# UNITED STATES PATENT AND TRADEMARK OFFICE

09/725,165

Jose Geraldo Furtado Ramos

# Office Action Summary

FIG. 17-4 Fluidization regimes. [Adapted from Grace, Chu J., Chem. Eng., 61, 353-363 (1986).]

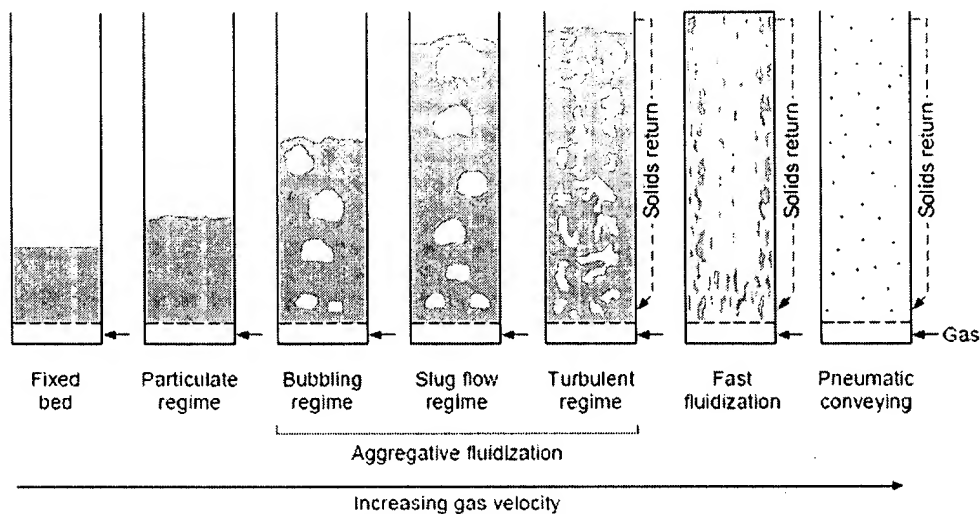
Regarding item (1), the recitations with respect to a specific level of particles within the cyclone legs (as now recited in claim 1), as well as a specific level of the fluidized bed above the junction (argued above, but not recited in claim 1 as amended), add no further patentable weight to the claims, because the specific level of the particles within the cyclone legs or the fluidized bed ultimately depends on the manner in which the claimed apparatus is intended to be operated. For instance, as is well known in the art of cyclone design, "[t]he extent to which the dipleg of a cyclone is filled with exiting solids depends on the pressure balance around the cyclone and its dipleg," (Zenz, page 813, under "Pressure Balance"). The "pressure balance", however, is a process variable and not an apparatus limitation. Also, as is well known in the art of fluidization, for a given amount of solid particulates, the level of the fluidized bed of particulates may vary

widely depending on intended use, as a function of the fluidizing gas velocity. See Regime Diagram, below (FIG. 17-4 from Perry's Chemical Engineering Handbook, 7th edition).

JONES' radius-curved termination

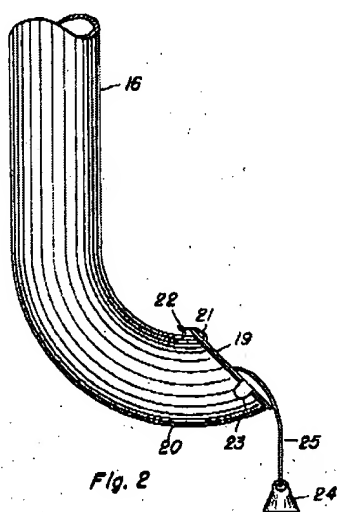
The Examiner respectfully disagrees. It is unclear as to how the radius-curved termination as taught by Jones would differ in function from the radius-curved termination as claimed by Applicants because it appears that the angle of both terminations is essentially the same (note the attached figures below).

APPLICANTS' radius-curved termination

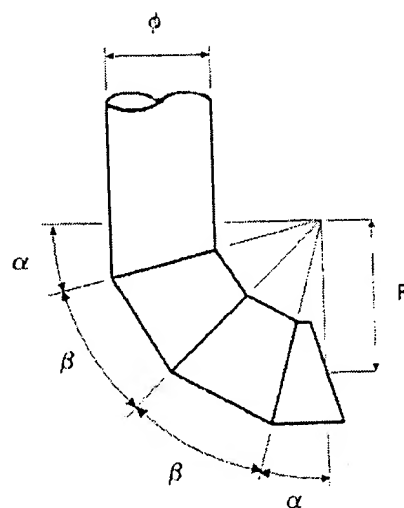
Hence, both the radius-curved terminations of Jones and of Applicants should inherently function similarly or identically, by directing a descending mass flow of dense phase solids into a plane orthogonal to an ascending gaseous flow.
